THE CINCINNATI GAS & ELECTRIC COMPANY

ZSM-84-183

RE: Wm. H. Zimmer Nuclear Power Station, Unit 1 -
Request for Additional Information for Environmental Review
of Applicant's Request to Withdraw the Zimmer OL Application

CG&E RESPONSE TO NRC REQUEST FOR ADDITIONAL INFORMATION FOR
ENVIRONMENTAL REVIEW OF APPLICANT'S REQUEST TO WITHDRAW THE ZIMMER
OL APPLICATION

Figures 3.9-1, 3.9-2

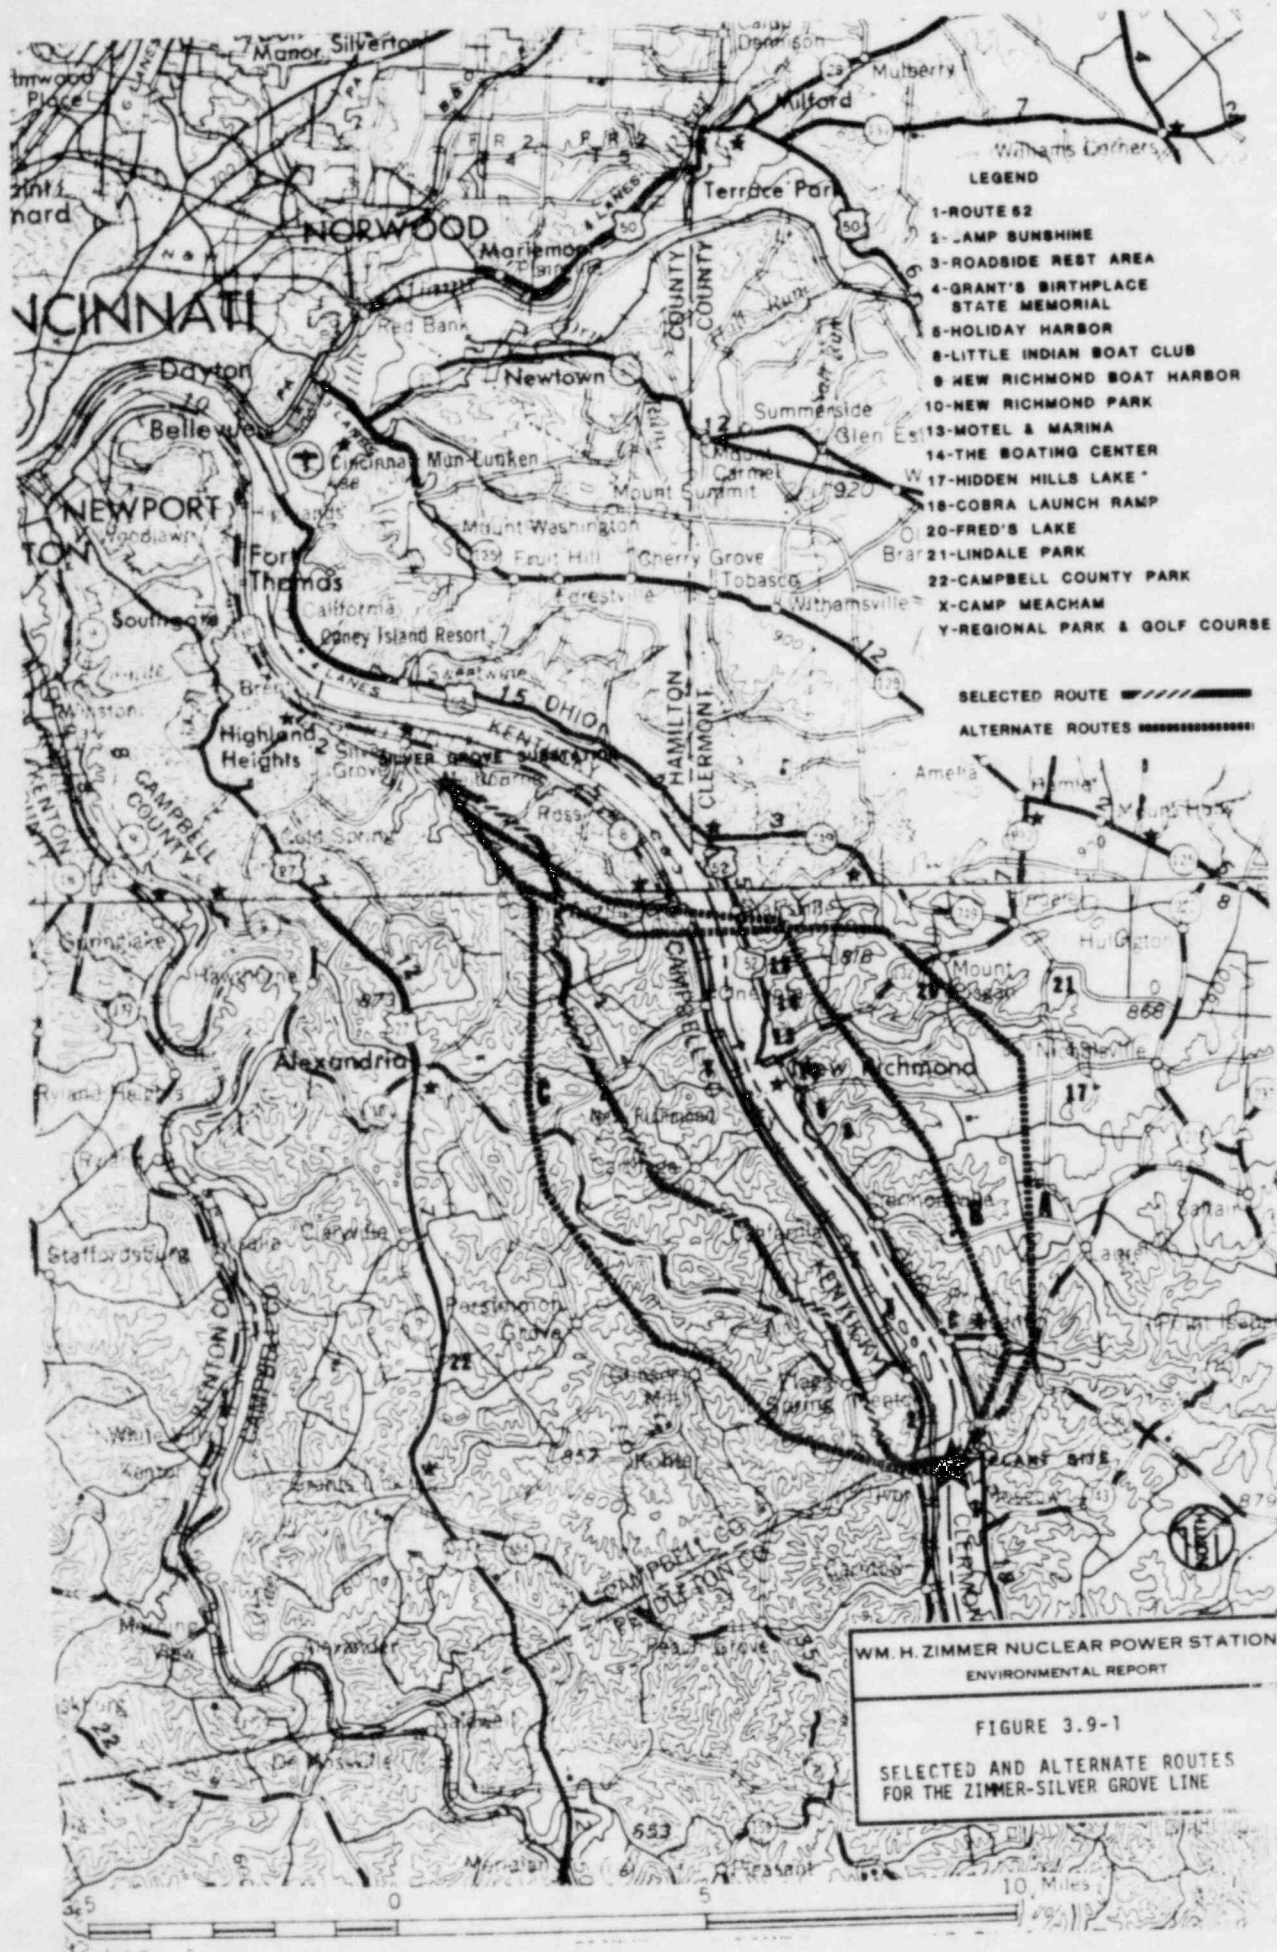
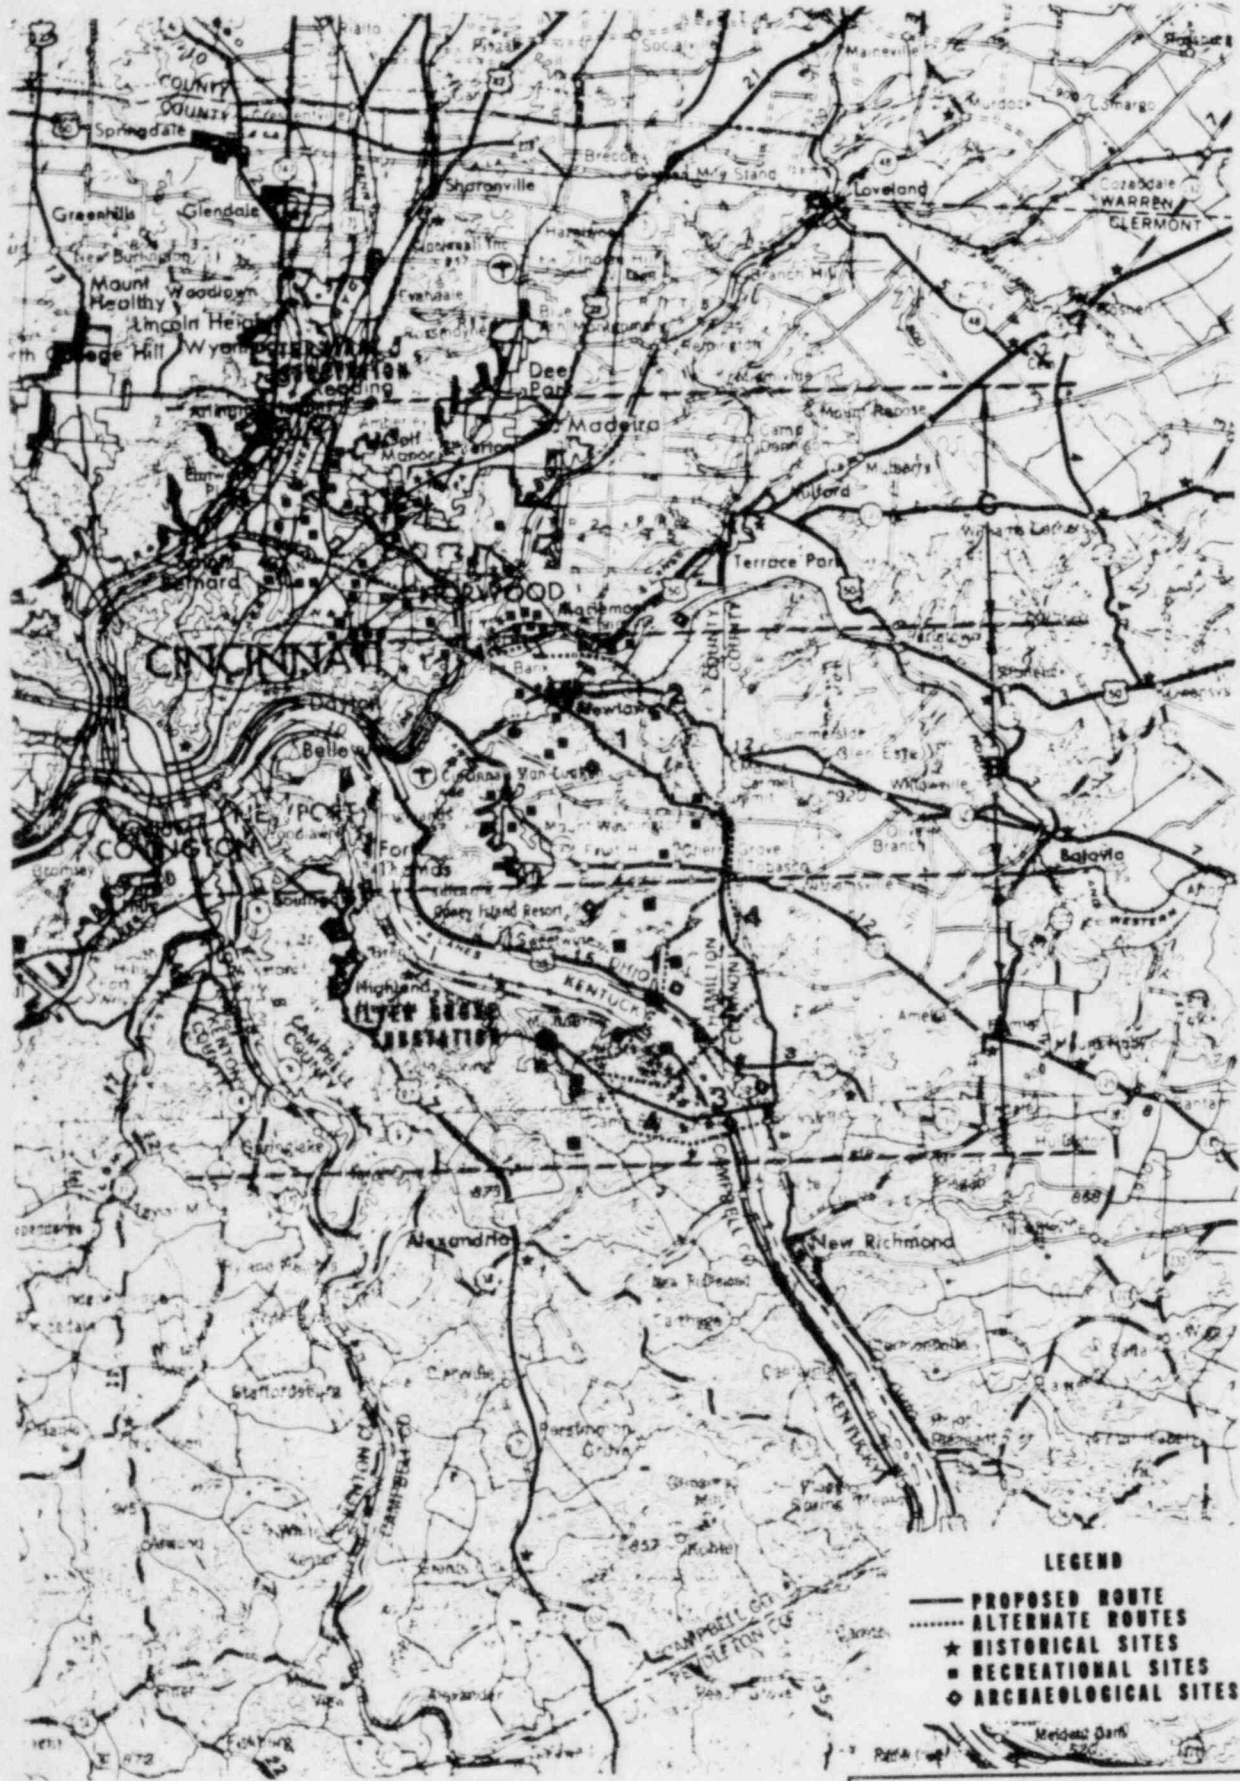
Provide a site plan showing areas (including transmission corridors) disturbed by construction-related activities. Identify the specific use of each disturbed area. Estimate acreage for each such disturbed area.

Maps showing transmission corridors associated with the Zimmer Station were previously submitted to NRC as Environmental Report-Operating License Stage (ER-OL) Figures 3.9.1 and 3.9.2. These figures have been reproduced and are provided as Appendix I to this report. Construction of these lines has been completed. The Zimmer-Silver Grove and Silver Grove - Terminal transmission lines were addressed in ER-OL, Section 9.1.
